Access Compliance Report

Public Rights-of-Way

(Curb Ramps)

Intersection ID: 47914	Main Street: MEARN_RD	Cross Street: ROOK_RD	Location:	N
ADA ID: 1673B2B02AFD	Ramp Type: PerpDiag	Initial Pass/Fail: Fail	Overall Compliance: No	Severity Score: 13.75
Codes/Mitigation Info/Possible Solution		Field Measurements/Component Compliance

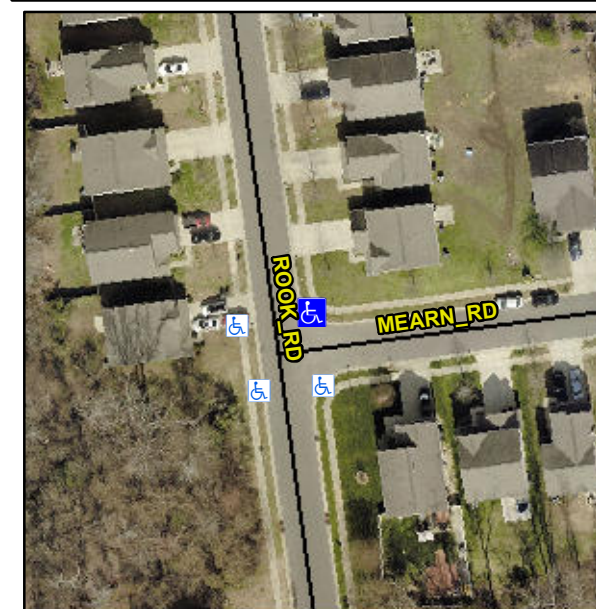
R304.2.2, R304.5.3

Compliance	Description	Data	Compliance	Description	Data
N/A	Ramp Length (in)	47.0	No	Ramp Slope (%)	10.0
Yes	Ramp Width (in)	49.0	No	Ramp XSlope (%)	3.5
N/A	Flare Type LT	N/A	N/A	Flare Type RT	N/A
N/A	Flare Slope LT (%)	N/A	N/A	Flare Slope RT (%)	N/A
N/A	Flare Traversable LT?	N/A	N/A	Flare Traversable RT?	N/A
N/A	Landing Length (in)	N/A	N/A	DWS Provided?	N/A
N/A	Landing Width (in)	N/A	N/A	DWS Contrast?	N/A
N/A	Landing Slope (%)	N/A	N/A	DWS Length (in)	N/A
N/A	Landing X Slope (%)	N/A	N/A	DWS Full Width?	N/A
N/A	Landing Curb? (Y/N)	N/A	N/A	DWS Offset (in)	N/A
N/A	Shared Landing?	N/A			
N/A	Gutter Ponding?	N/A	N/A	Gutter Slope (%)	N/A
N/A	Gutter Lip Ht (in)	N/A	N/A	Gutter X Slope (%)	N/A
N/A	Painted X Walk1?	No	N/A	Painted X Walk2?	No
	X Walk 1 Direction	To W		X Walk 2 Direction	To S
N/A	X Walk 1 Width (in)	N/A	N/A	X Walk 2 Width (in)	N/A
	X Walk 1 Slope (%)	2.9		X Walk 2 Slope (%)	1.4
	X Walk 1 X Slope (%)	1.7		X Walk 2 X Slope (%)	1.4

Remove & Replace Curb Ramp With Two New Directional Ramps or Equivalent.
